PLANNING AND ZONING BOARD STAFF REPORT

Kia Delray

Meeting	File No.	Application Type
October 20, 2025	2024-259-SPR-LV3	Level 4 Site Plan Modification, with 2 Waivers
Property Owner	Authorized Agent	
Myers Auto Group DK LLC	Mike Troxell, Thomas Engineering

Provide a recommendation to the City Commission on a Level 4 Site Plan Modification, with Architectural Elevations and Landscape Plan, for Kia Delray to demolish the existing building at 2255 South Federal Highway and construct a two-story dealership with a three-story parking garage to the rear, and two associated waivers to (1) reduce the required number of bicycle showers, and (2) reduce the required setback of the rear wall.

Figure 3.20 – Setbacks for Buildings over 300' wide on East side of Federal Highway

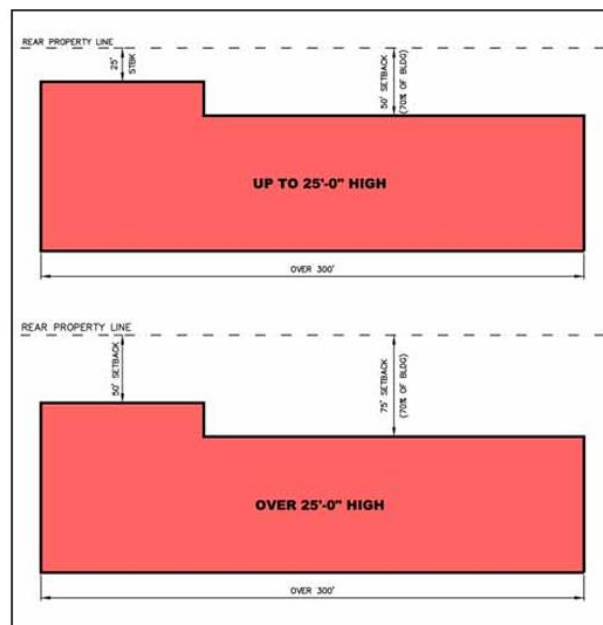
The structure is greater than 25 feet in height, so the minimum building setback is 50 feet and at least 70% of the building must meet a minimum setback of 75 feet. The proposal rear minimum setback is 60.17 feet, specifically where the stairwells extend, and majority of the building is setback 68.25 feet. The residential neighborhood to the rear is separated with a 50-foot public right-of-way.

The Board must consider if the proposed setback and the adjacent public right-of-way is adequate distance from the adjacent residential properties, and if the minimal projections and recessions are sufficient to reduce the massive scale and uniform appearance of the large parking garage structure.

Figure 3.21 – Landscape Buffer Detail - Commercial Property separated from Residential by Street or Alley

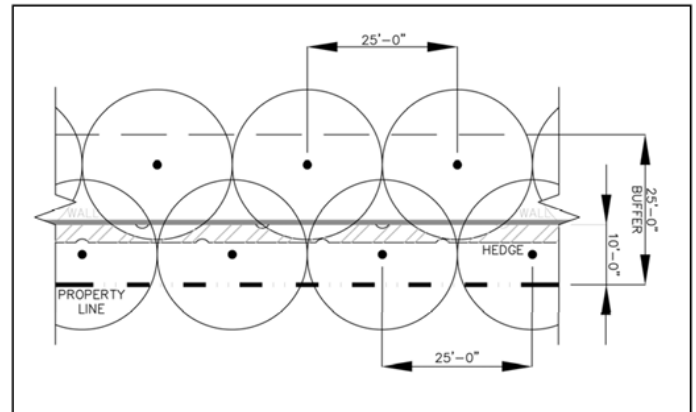
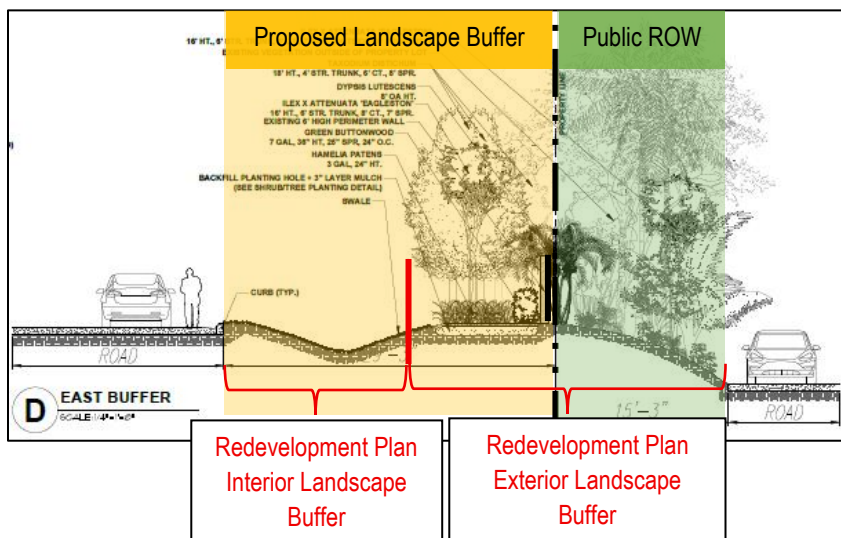
This buffer standard applies specifically to residential properties separated by a street or ally; therefore, the Redevelopment Plan intention is to buffer the residential properties with 10 feet of landscaping plus the separation from the public right of way including any existing landscape, resulting in a more robust buffer. The project proposes new trees west of the property line with 25-foot spacing, as well as additional trees within the public right-of-way to comply with the 25-foot spacing.

The applicant does not intend to comply with this recommended landscape standard in the Redevelopment Plan, and is requesting relief from LDR Section 4.6.5(F) to maintain an existing wall on the property line instead of the required 2-foot setback (image at right). Further analysis of the wall setback relief is provided in this report.

While the proposed landscape plan includes new trees and utilizes existing vegetation within the public right-of-way, the overall buffering treatment along the eastern edge requires careful consideration. The Redevelopment Plan envisions a stronger landscaped transition to preserve the comfort and privacy of adjacent residential areas. Ensuring an appropriate balance between functional site design and neighborhood sensitivity will be essential to maintaining the character and long-term stability of the corridor. The Board must consider if utilizing solely the public right-of-way landscaping is sufficient buffering for the adjacent residential community and whether the combination of on-site and right-of-way landscaping achieves this balance and remains consistent with the intent of the South Federal Highway Redevelopment Plan.

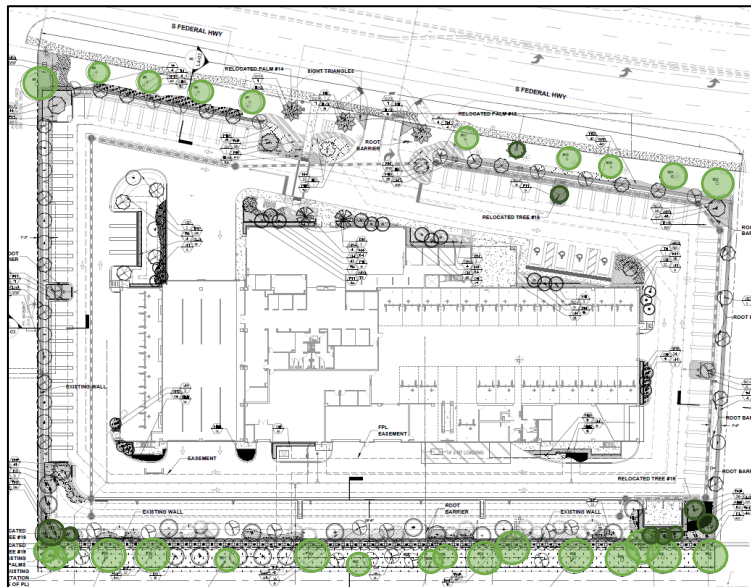
The site contains an existing wall located directly on the property line, adjacent to the residential area. However, pursuant to LDR Section 4.6.5(F), walls are required to be set back a minimum of two feet from the property line to provide adequate area for vegetation. As the proposal consists of a full demo and new construction, all applicable regulations must be met for the entirety of the site. The applicant has requested relief to maintain the existing wall setback.

The proposal utilizes the existing foliage on the public right-of-way to screen the wall, rather than the required two-foot landscape strip. The Planning and Zoning Board must consider whether the additional landscaping buffer is necessary to provide adequate screening for the adjacent residential communities, or if the existing vegetation provides an appropriate amount of screening and it is better to maintain the existing landscaping than remove and replace.
